AFFIDAVIT

TANGLEWOOD SUBDIVISION-PLAT NO. 3, CITY OF MANCHESTER, SEC. 29, T89N, R5W OF THE FIFTH P.M., DELAWARE COUNTY, IOWA

FINAL PLAT

TANGLEWOOD SUBDIVISION – PLAT NO. 3, CITY OF MANCHESTER
SEC. 29, T89N, R5W OF THE FIFTH P.M, DELAWARE COUNTY, IOWA

PROJECT NO.	01–36
SCALE:	1"=150'
DATE:	2/28/2005
DRAWN BY:	RLR
CHECKED BY:	JDG
FIELD BK:	D.L.
REVISED	3/18/2005
SHEET	1 OF 9

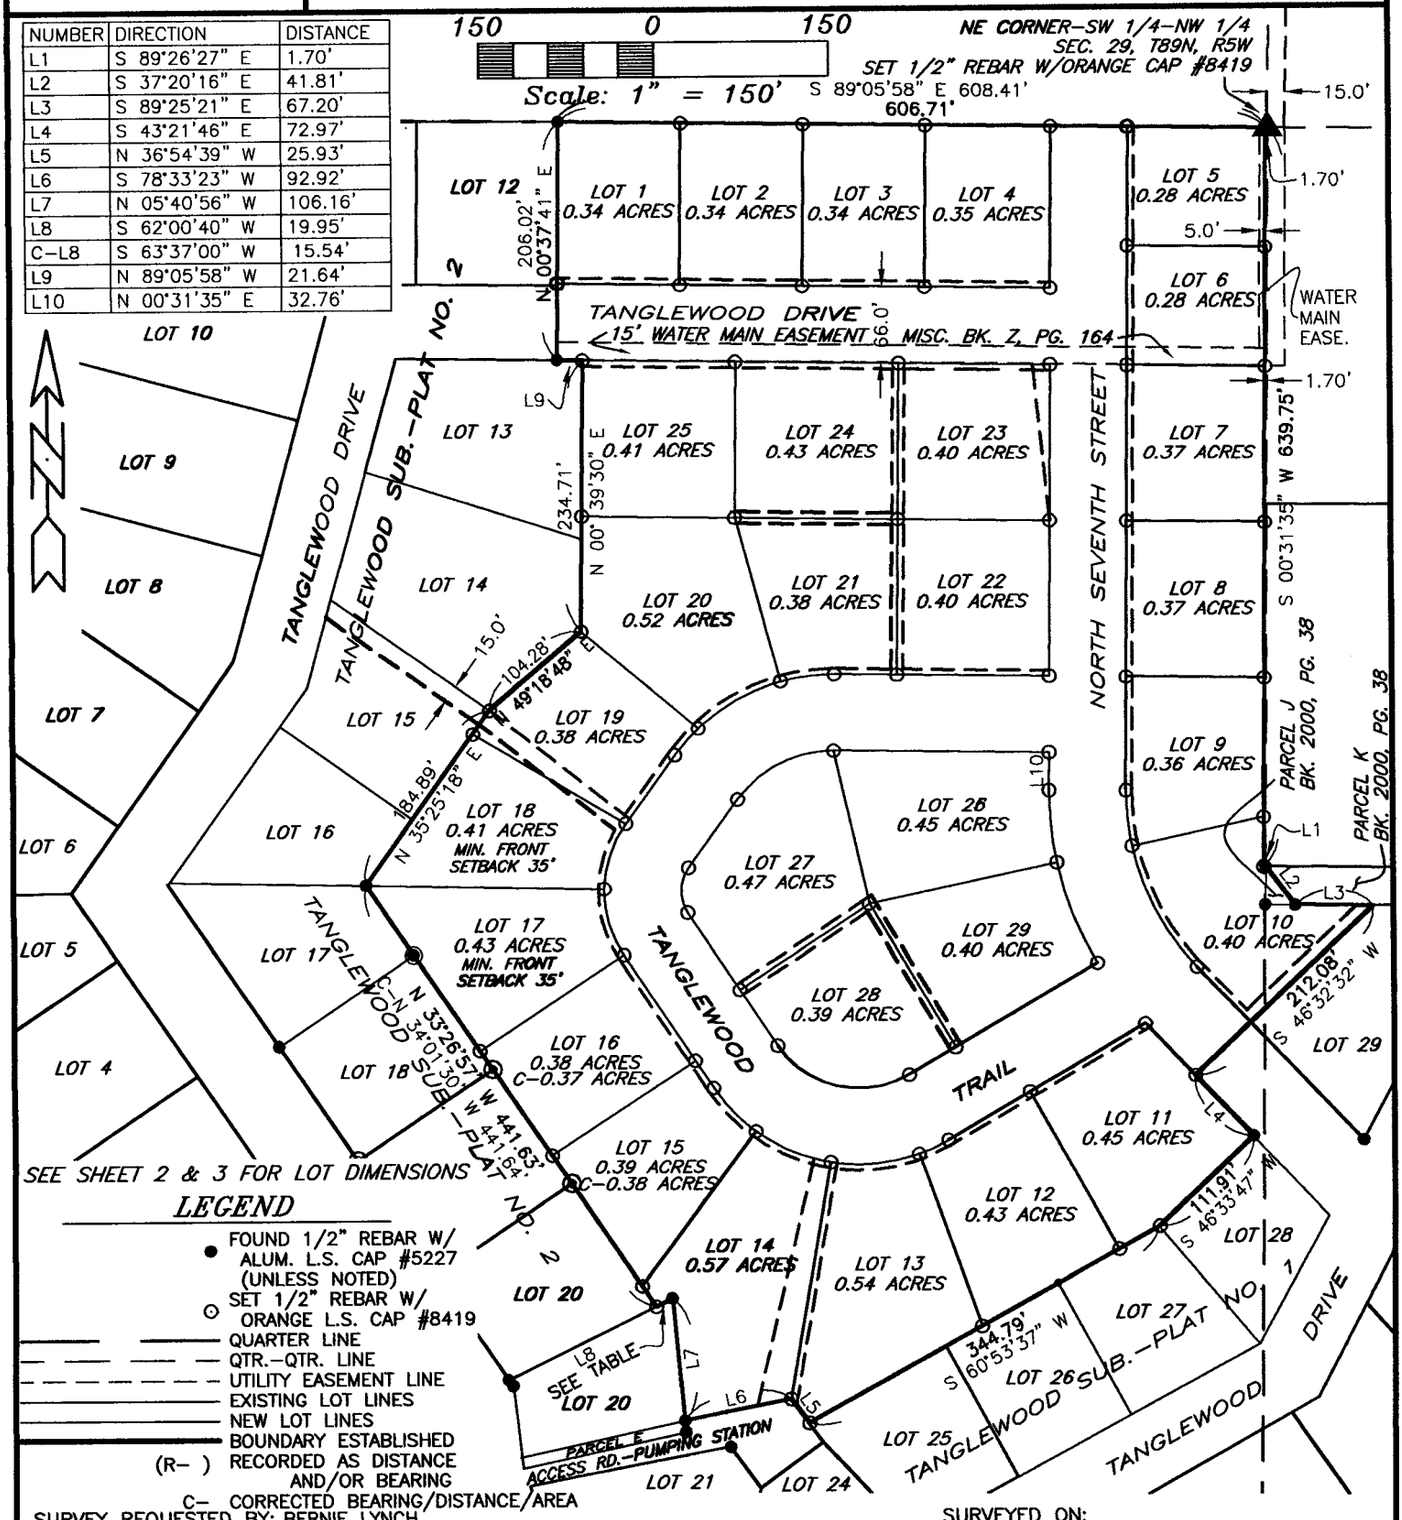
3) A scrivener's error was made on the Lot Areas of Lots 15 & 16 in the Plat of Survey on Sheet 1 of 9 and Sheet 3 of 9, where it reads:

Lot 15: 0.39 ACRES and should read: Lot 15: 0.38 ACRES

Lot 16: 0.38 ACRES and should read: Lot 16: 0.37 ACRES

4) A scrivener's error was made on the Subdivision Boundary Dimensions in the Plat of Survey on page 1 of 9 and Sheet 3 of 9, where it reads:

Line L8 = S 62° 00' 40" W 19.95'

Line L8 = S 63° 37' 00" W 15.54'

NUMBER	DIRECTION	DISTANCE
L1	S 89°26'27" E	1.70'
L2	S 37°20'16" E	41.81'
L3	S 89°25'21" E	67.20'
L4	S 43°21'46" E	72.97'
L5	N 36°54'39" W	25.93'
L6	S 78°33'23" W	92.92'
L7	N 05°40'56" W	106.16'
L8	S 62°00'40" W	19.95'
C–L8	S 63°37'00" W	15.54'
L9	N 89°05'58" W	21.64'
L10	N 00°31'35" E	32.76'
